TECHNICAL SERVICE BULLETIN

HA22-002

A/C COMPRESSOR SERVICE INFORMATION

APPLIED VEHICLES: 2020 Titan/Titan XD (A61)

Figure 1

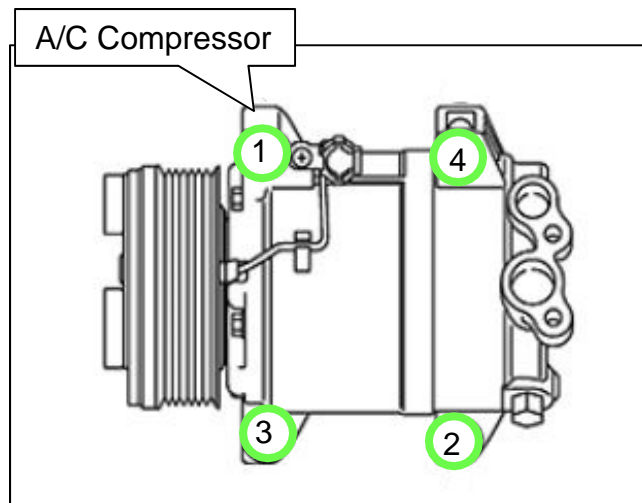
If the A/C Compressor on an **APPLIED VEHICLE** is removed or replaced for any reason, follow the updated torque sequence, as shown in Figure 1.
